Access Compliance Report Public Rights-of-Way (Curb Ramps)

Main Street: FLINTRIDGE_AVE		Cross Street: TISBURY_WAY		Location:	N
ADA ID: RPRK211104133919	Ramp Type:Type 1 - Perpendicular	Initial Pass/Fail: Fail	Overall Compliance: No	Severity Score:	30
Codes/Mitigation Info/Possible Solution			Field Measurements/Component Compliance

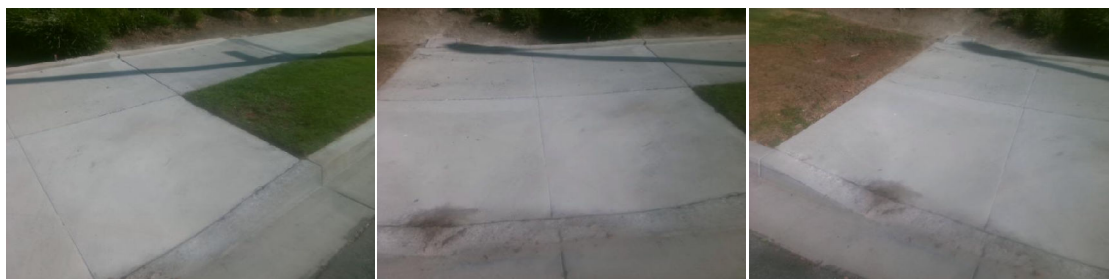
R204.3, R304.2.2, R304.5.3, STD 1115

Remove & Replace Entire Ramp.
